Front Spotlight Electrical Update

Bulletin Type:	TSB	Publication Date:	July 2023
Bulletin #(s):	23-101	Make(s):	Jayco & Entegra Coach
Job Code(s):	9803586	Model(s):	Launch (19Y), Terrain (19Y), Launch LE (19L), Terrain LE (19L)
Flat Rate(s):	0.75 Hr. – Spotlight electrical Repair	Model Year(s):	2021-2024

Incident:	Current on the spotlight is pulling higher amps than acceptable causing issues with Firefly.
Affected Units:	2021-2023 Jayco Terrain (19Y) and Terrain LE (19L); 2021-2024 Entegra Coach Launch (19Y) and Launch LE (19L)
Parts Kit:	23-101JM 2 - CONNECTOR,SPLICE 3 WIRE CLR PLSTC WAGO 12-24GA 2 - CONNECTOR,SPLICE 2 WIRE CLR PLSTC WAGO 12-24GA 1 - HARNESS,WIRE LIGHTBAR W/RELAY 1 - SWITCH,RKR DASH SPST O/F HELLA SPOTLIGHT 1 - HOLDER,FUSE IN-LINE 14GA BLUE Screw Gun w/Square Bit Ratchet with extension and 10mm socket E12 Torx Socket Wire Strippers/Crimpers
Misc. Tools & Supplies:	N/A
Parts Return Information:	N/A

Fig. 3

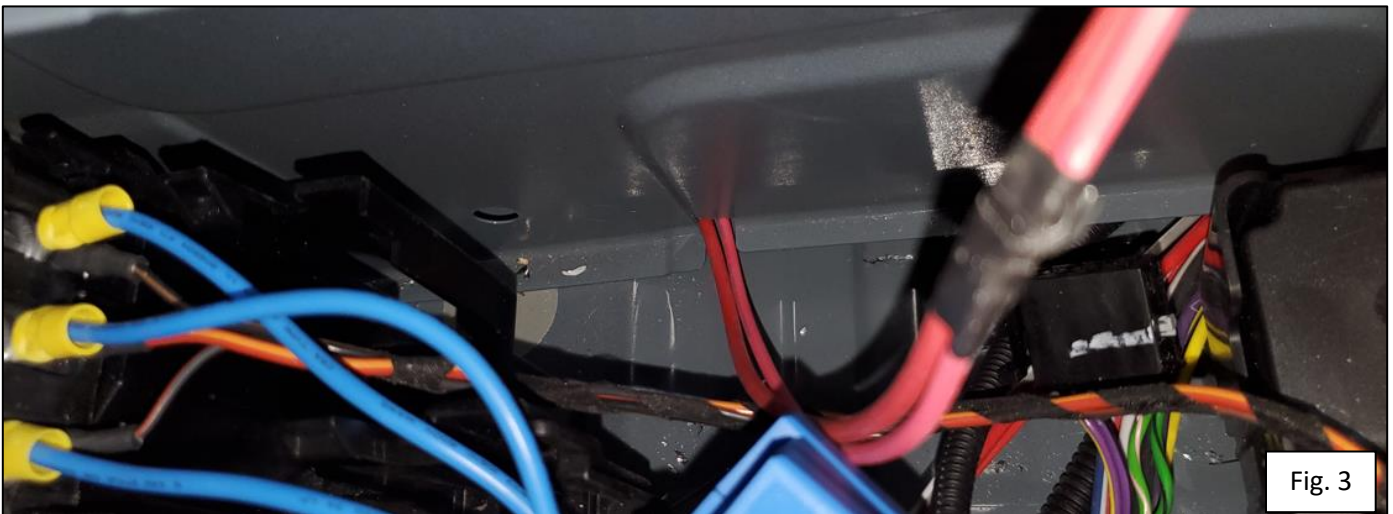
4. Route the Pink and Red wires from the relay harness jumper (Figure 3)
 - A. Locate the outer support block on the step assembly.
 - B. Route the Pink and Red wires from the Mid-Ship seat area to the driver seat base.

Fig. 4

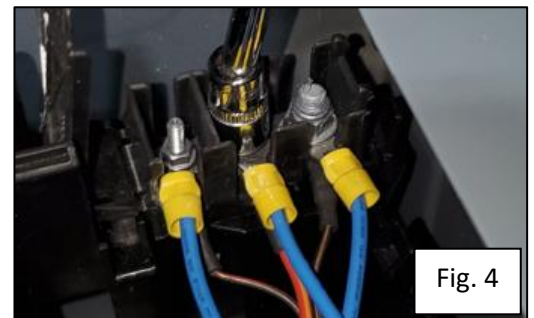
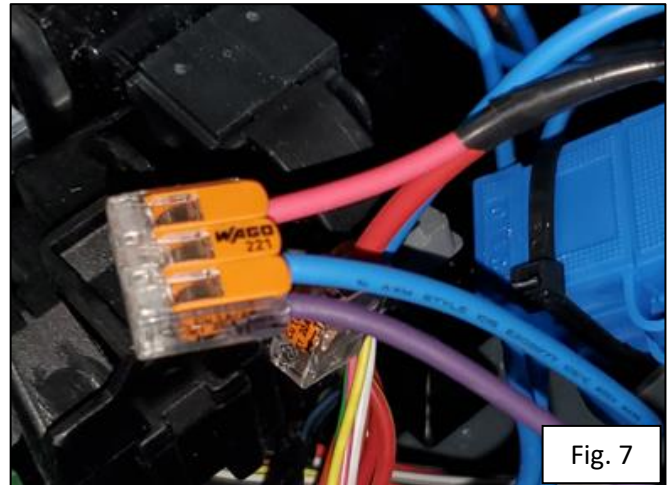
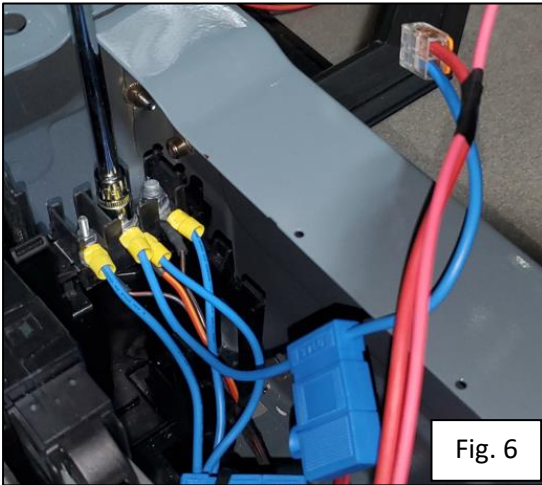
- C. Reaching down inside the OEM seat base to the pass-thru opening, locate the wires and pull through
5. Remove the cover plate installed over the (3) OEM mounting studs.
6. With a ratchet, extension and 10mm socket, remove the mounting nut from the center stud. (Figure 4)

Fig. 5

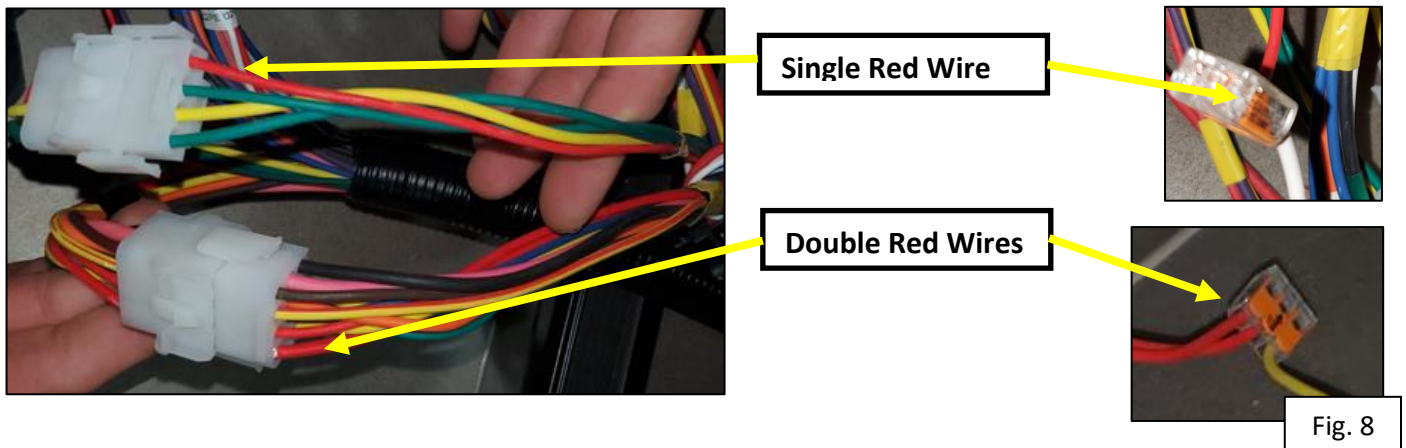
7. Add a 15A inline fuse holder to the center stud and tighten. (Figure 5)
